3580 W. 41ST AVE. DE 404817	DATE 2000 05 24	
	DRAWN WGKS	
CITY OF VANCOUVER PLANNING DEPARTMENT	FILENAME :F:\FRM10FDEV\3580W41.DWG

Commercial / Residential Bldg.
3364 - 3586 West 41st Avenue
Vancouver, B.C.

2. Address: 3580 West 41st Avenue
DA: 404817
Zoning: C-2
Application Status: Complete
Architect: Ramsay Worden
Owner: Van City Enterprises
Review: First
Delegation: Doug Ramsey
Staff: Anita Molaro

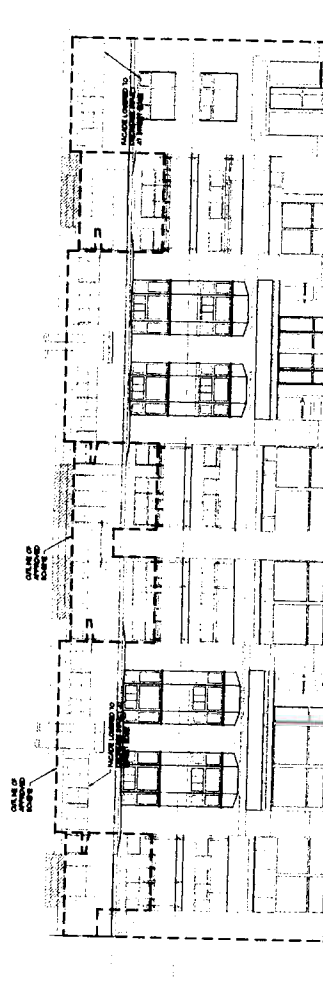
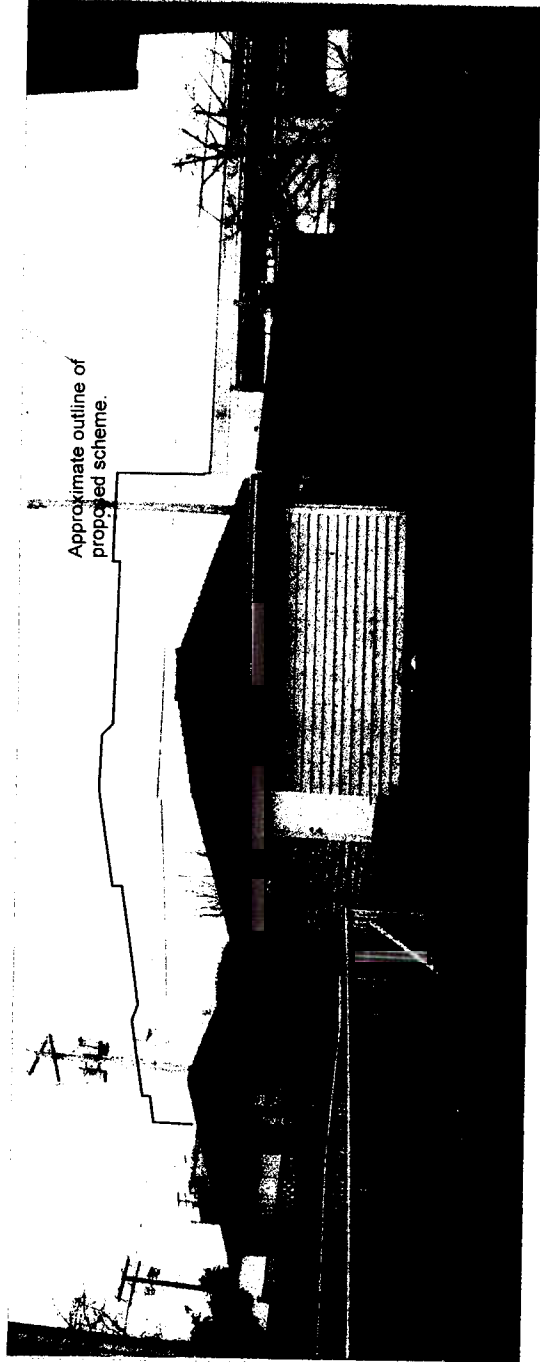
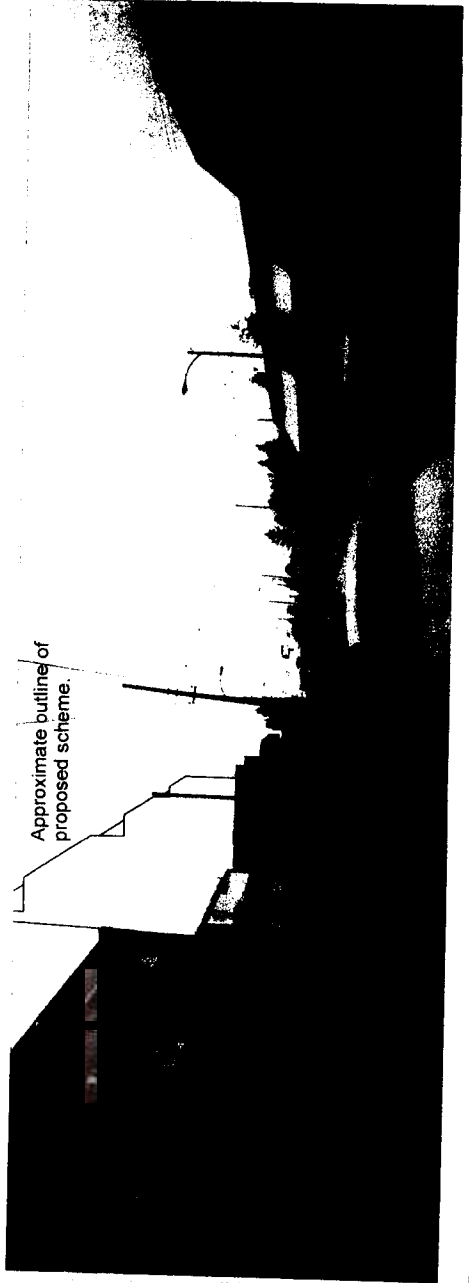
The Panel advised that they approved of the C-2 zoning as a vehicle for urban infill, and compared this project as a basic design that C-2 was intended to fulfill and that perhaps the City should be more relaxed about minuscule things like an extra foot or two at the one corner of a building, rather than expect a project to evolve into strange contortions in order to fulfill a zoning guideline. It was felt that the form of articulation on the street and the type of proposed materials and proportions were *exemplary*. Others commented that the stepped down corner of the roof at the rear should be straightened out, as it gave the appearance of a settlement problem. There were favourable comments about the proposed materials.

The Chair's summarized the Panel's support of this project and referred to the positive comments about C-2 infill strategy and that this project appeared to fulfill the promise of that strategy. He also referred to the approval of the signage. The Chair confirmed that the "settlement problem" of the southeast corner needed to be handled with a better resolution in spite of the height overage. However, it appeared that mechanical element on the roof appeared to be 'floating' and would require a revisit by the applicant; and although there were some concerns about views regarding the adjacent buildings, as well the commercial in the lane, it was generally felt that this project could be achieved.
